**Re: Defect Information Report – Supplemental Report No. 3
08V-154, FL-529, M2 High Current Tail Lamp PDM**

Subject: High Current Tail Lamp PDMs

Models Affected: Specific Freightliner Business Class M2 vehicles with high current tail lamp PDMs manufactured between June 15, 2005, and January 2, 2007.

August 2008
FL529A
NHTSA #08V-154

Fig. 1, High-Amp Taillight PDM Installation

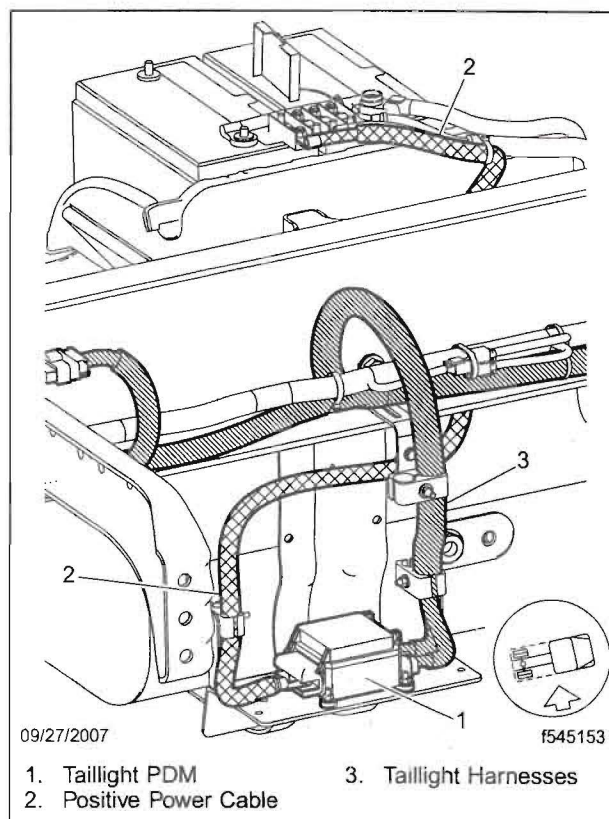
1. Check the base label (Form WAR259) for a completion sticker for FL529 (Form WAR260) indicating this work has been done. The base label is usually located on the passenger-side door about 12 inches (30 cm) below the door latch. Inspect the base label (Form WAR259), located on the front wall under the dash, for a completion sticker (Form WAR260 or Form WAR261). If a sticker is present for FL529 or for SF377, no further work needs to be done. If no sticker is present, proceed with the steps below.
2. Shut down the engine, set the parking brake, and chock the tires.
3. Disconnect the batteries at the negative terminals.
4. Find the positive power cable on the high current taillight PDM and trace it back to the battery. Disconnect the cable from the battery and the PDM and discard the cable. See Fig. 1.
5. Disconnect the taillight harnesses from the high-amp taillight PDM. See Fig. 1.

Fig. 2, PDM Mounting

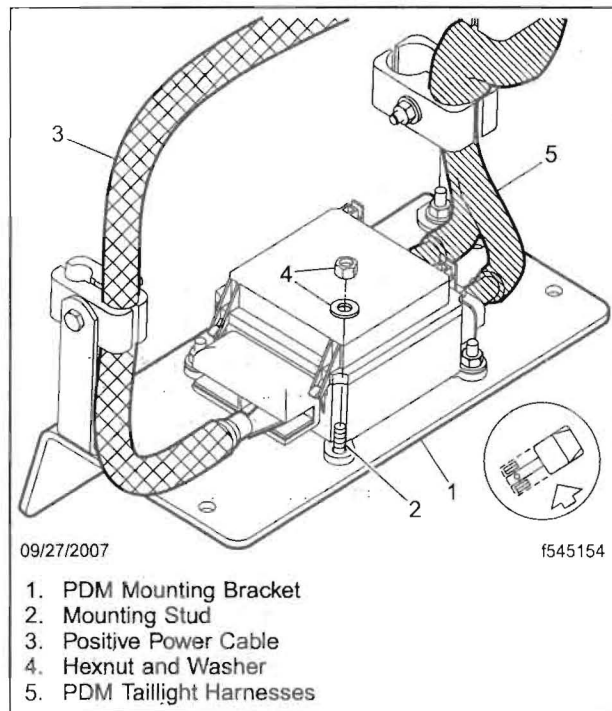
6. Remove and discard the two cable clamps that support the taillight harnesses.
7. Remove and discard the four nuts that hold the PDM to the mounting bracket, then remove the PDM. See Fig. 2.

Fig. 3, PDM Mounting Bracket Installation

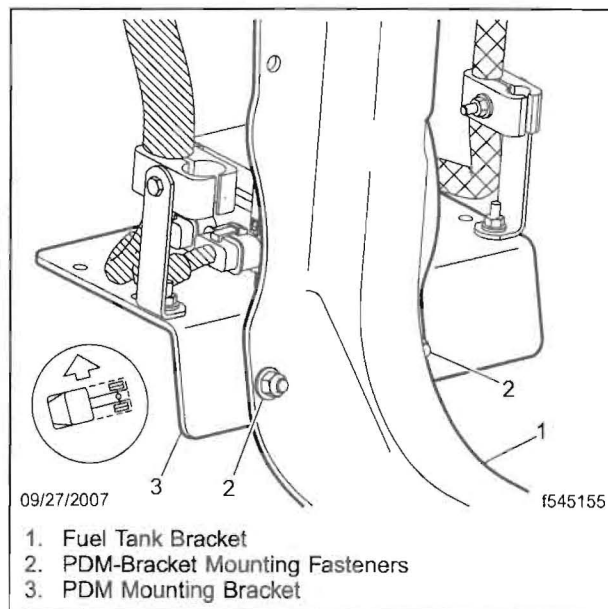
8. Remove and discard the two bolts and nuts that hold the PDM mounting bracket to the fuel-tank bracket. See Fig. 3.

Fig. 4, Taillight Harnesses to be Removed

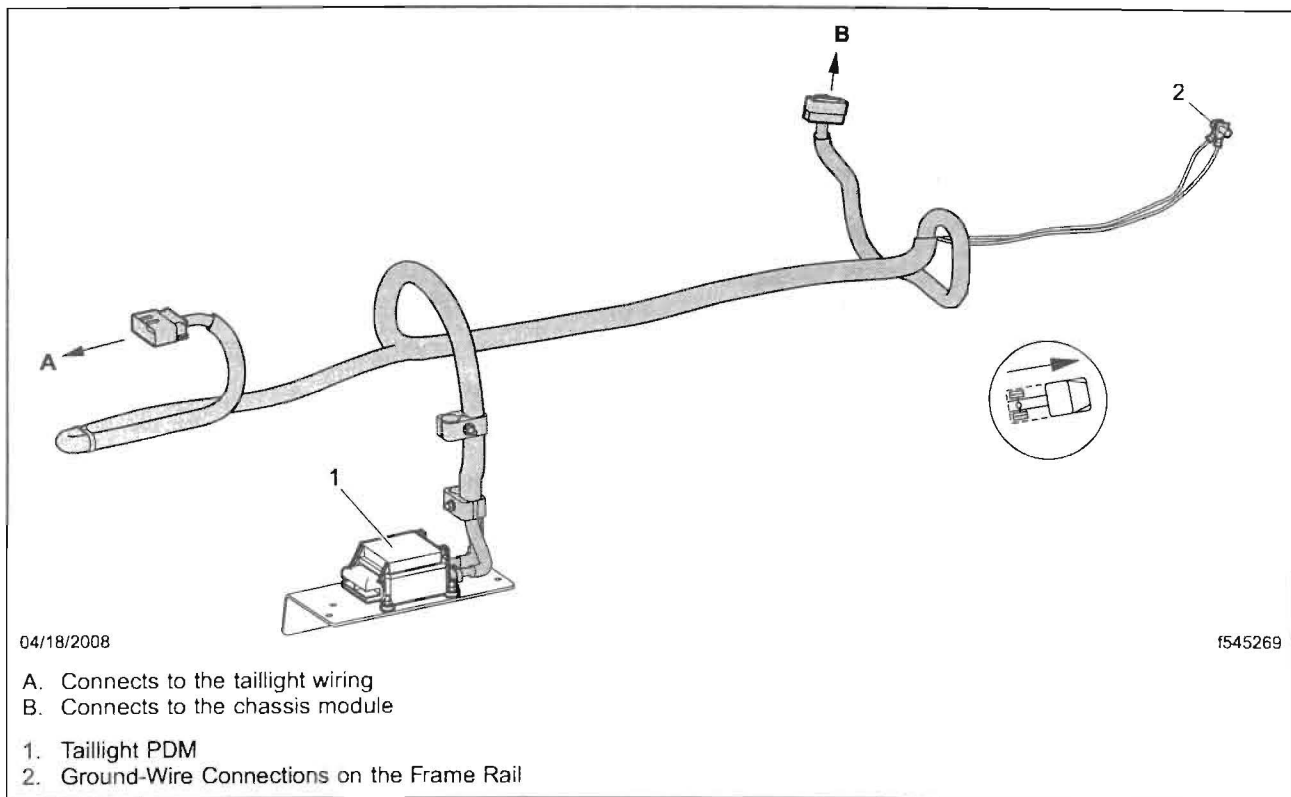
9. Remove and discard the mounting bracket.
10. If the vehicle will not be used to tow a trailer, discard the taillight PDM and go to the next step.
If the vehicle will be used to tow a trailer, discard the PDM and go to "Installing a New Taillight PDM in the Cab," in these Work Instructions.
11. Disconnect the PDM taillight harnesses from the vehicle as follows. See **Fig. 4**
 - 11.1 Disconnect the rear section of the harness from the taillight wiring.
 - 11.2 Disconnect the forward section of the harness from the chassis module.
 - 11.3 Disconnect the two harness ground wires from the stud on the frame rail.
 - 11.4 Remove and discard the PDM taillight harnesses.

12. Uncoil the original taillight harness (to which the PDM harness was previously connected), and route it along the frame rail, up to the chassis module.
13. Secure the taillight harness with tie straps as needed, then connect it to the chassis module.
14. Connect the batteries.
15. Clean a spot on the base label (Form WAR259). Write FL529 on a blank, red completion sticker (Form WAR260), and attach it to the base label.
16. Remove the chocks.

Fig. 5, View Looking Down on Cab Deck

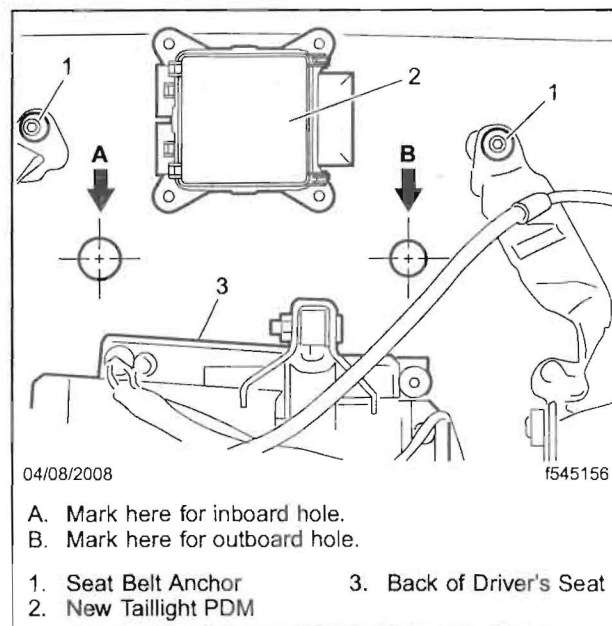
1. Using the new taillight PDM unit as a guide, locate a position behind the driver's seat to mount the unit, then locate the PDM near the backwall and centered between the seat belt anchor bolts.
2. Place a mark on the floor about 3 inches (76 mm) to the left and right of the new PDM. See Fig. 5.

NOTE: Before drilling, always inspect to make sure there are no electrical, fuel, HVAC, or air lines in the way. Do not drill into the cab structural supports.

Fig. 6, Cab Installation of Taillight PDM

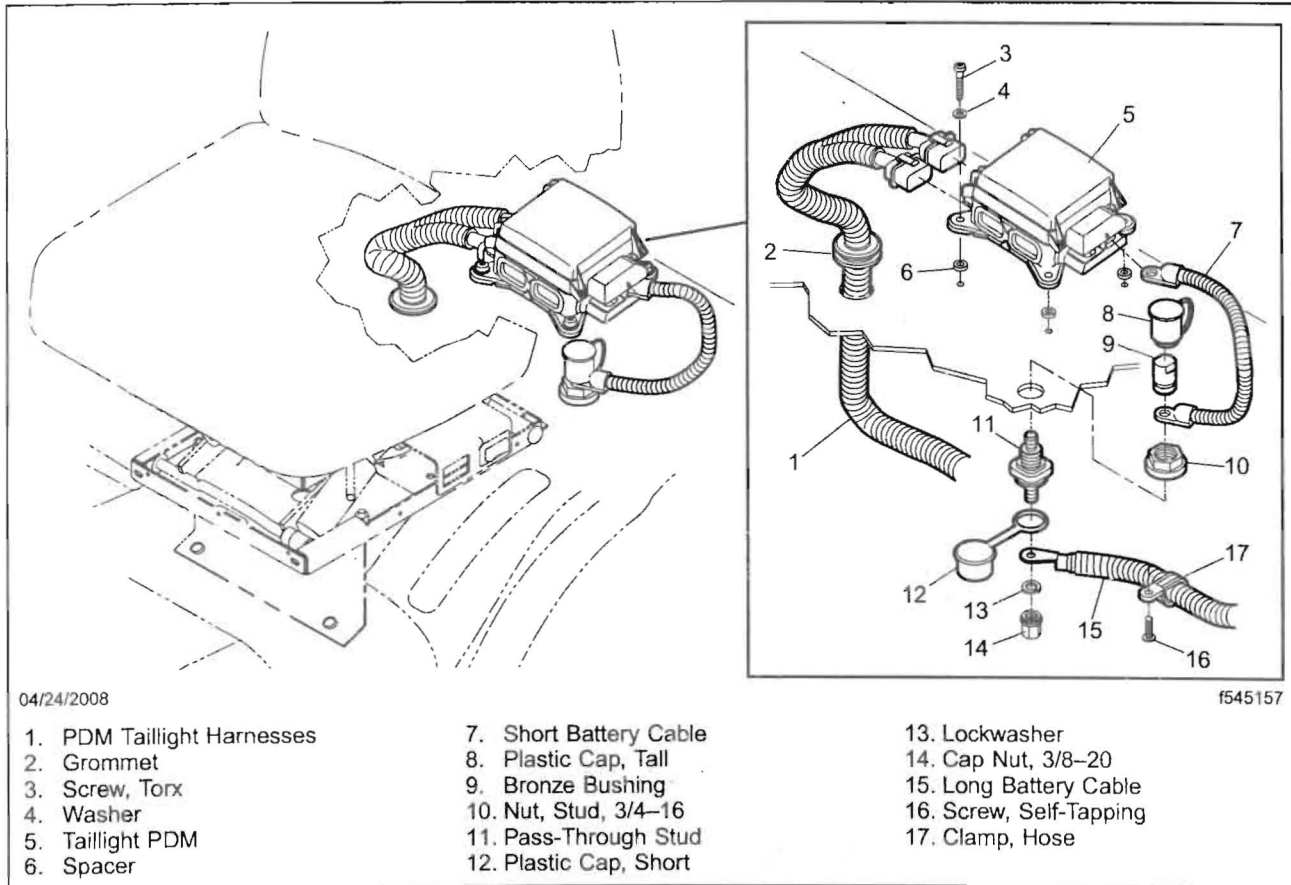
10. Install the grommet from the kit over the PDM harness and seat the harnesses in the inboard (1-3/8 inch, or 35 mm) hole. See Fig. 6.
11. Using the four spacers, washers, and screws from the kit, mount the PDM to the floor. **NOTE:** Please use the washers (p/n 23-10900-014) from the 25-FL529-000 kit. Discard the washers (p/n 23-10900-010) from the 25-SF377-000 kit.

13. Install the short battery cable from the kit. See Fig. 6.

Using a Nyloc M8 hexnut and flatwasher from the kit, connect one end of the cable to the PDM; then using the bronze bushing from the kit, connect the other end to the pass-through stud.
